UNITED STATES PATENT AND TRADEMARK OFFICE

APPLICATION NO.	FILING DATE	FIRST NAMED INVENTOR	ATTORNEY DOCKET NO.	CONFIRMATION NO.
10/526,998	10/18/2005	Francesc Xavier Hernando Fernandez	TJA-102US	7992
23122	7590	12/26/2007		
RATNERPRESTIA			EXAMINER	
P O BOX 980			PATEL, VINOD D	
VALLEY FORGE, PA 19482-0980				
			ART UNIT	PAPER NUMBER
			3742	
			MAIL DATE	DELIVERY MODE
			12/26/2007	PAPER

Office Action Summary	Application No.	Applicant(s)	
	10/526,998	FERNANDEZ, FRANCESC XAVIER HERNANDO	
	Examiner	Art Unit	
	Vinod D. Patel	3742

DETAILED ACTION

FIG. 20

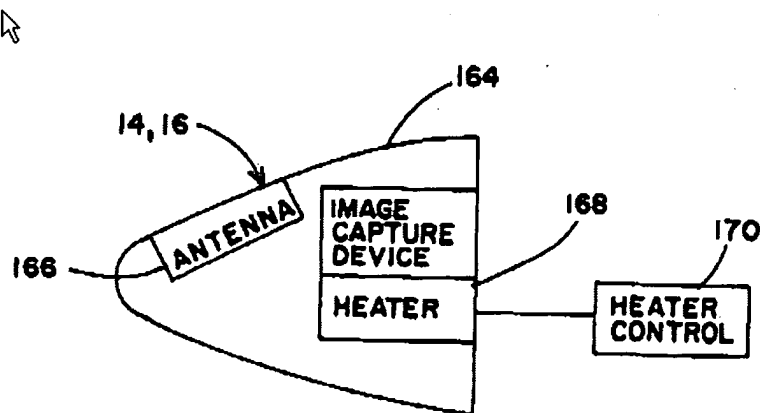
With respect to claim 28, Schofield et al. discloses an image acquisition unit (14, 16) with a heating device (168) for monitoring an exterior of a vehicle, comprising: a casing comprising a protected interior, a window closed by a transparent element and supporting means for supporting an optical system facing said window; image detection means located in said casing, facing said optical system and associated with connection means with the exterior, for supplying electrical signal and/or for bidirectional signal interchange; and heating means for providing thermal energy to said transparent element, or to an adjacent zone thereto as shown in the Figure 20.

With respect to claim 29, Schofield et al. discloses the image acquisition unit, wherein said heating means comprises at least one electrical heater (168) supplied with direct current from said connection means (Figure 20, column 20, lines 13-40).

With respect to claim 30, Schofield et al. discloses the image acquisition unit, further comprising control means (170) for controlling the operation of said electrical heater as shown in the Figure 20.

With respect to claim 37, Schofield et al. discloses the image acquisition unit, wherein said electrical heater comprises at least one electrical resistance directly applied on said transparent element as shown in the Figure 20.

FIG. 1

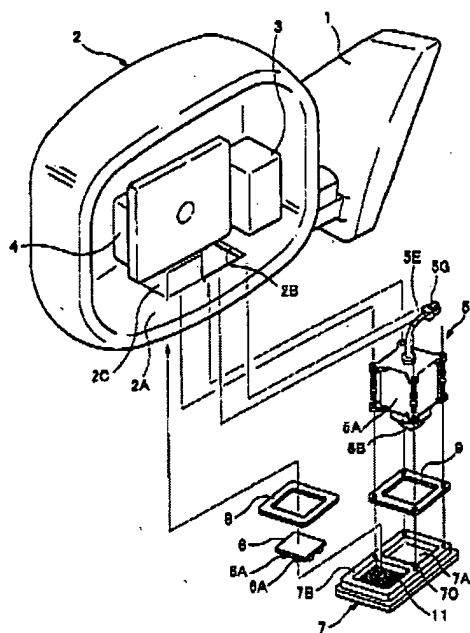
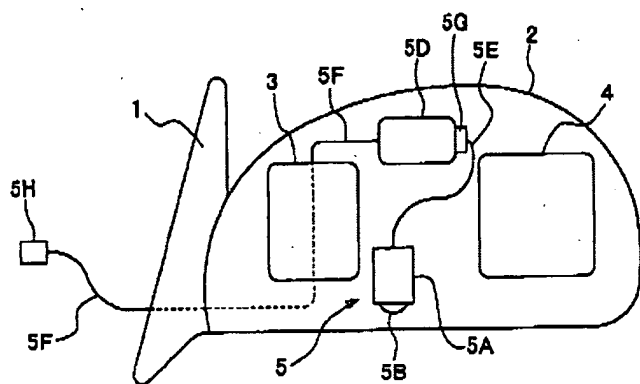
17. Applicant's arguments filed 10/5/07 have been fully considered but they are not persuasive. Fujikawa discloses a casing (2) comprising a protected interior, said casing defining a window closed by a transparent element (7) and supporting means defined by part of said casing for supporting an optical system inside said casing for supporting an optical system inside said casing and facing said window, image detection means located in said casing, facing said optical system and associated with connection means with the exterior for supplying electrical signals and for bidirectional signal interchange as shown in the Figures 1-7.

FIG. 20

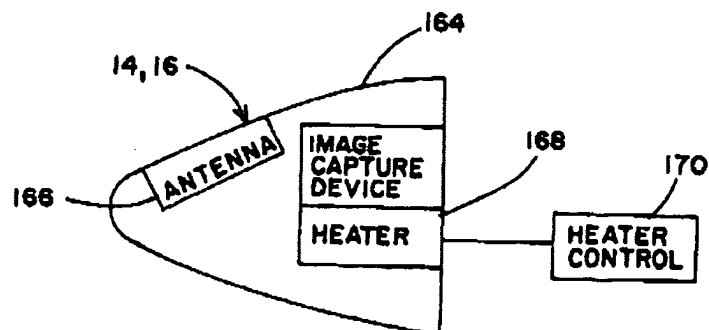
In response to the applicant argument that Schofield does not disclose heater 168 provides thermal energy to transparent element. The examiner respectfully disagrees with that statement. Heater 168 provides thermal energy to transparent element, see, Schofield discloses, column 18, lines 41-42, "A heater may be applied to each image capture device in order to remove dew and frost that may collect on the optics of the device.", column 20, lines 22-40 and column and column 20, lines 22-36, "A heater 168 may be associated with the image capture device in order to stabilize the temperature of the device in low ambient temperature conditions. A similar heater may be supplied in display 20 in order to improve its performance in low ambient temperature conditions. A heater control 170 is provided in order to control the energization of heater 168 and, if utilized, the heater in the display. Heater control 170, preferably, energizes heater 168 prior to the vehicle being started. This allows the temperature of the image capture device to be elevated to a more desirable temperature prior to the driver operating the vehicle. This may be accomplished by heater control 170 being a proximity detector which detects a device carried by the driver as the driver approaches the vehicle."

As shown in the Figures 1-20, Schofield shows casing comprising protected interior and window closed by transparent panel and supported by casing for supporting an optical system inside said casing, facing said optical system and connection means with the exterior, for supplying electrical signals and for bidirectional signal interchange.
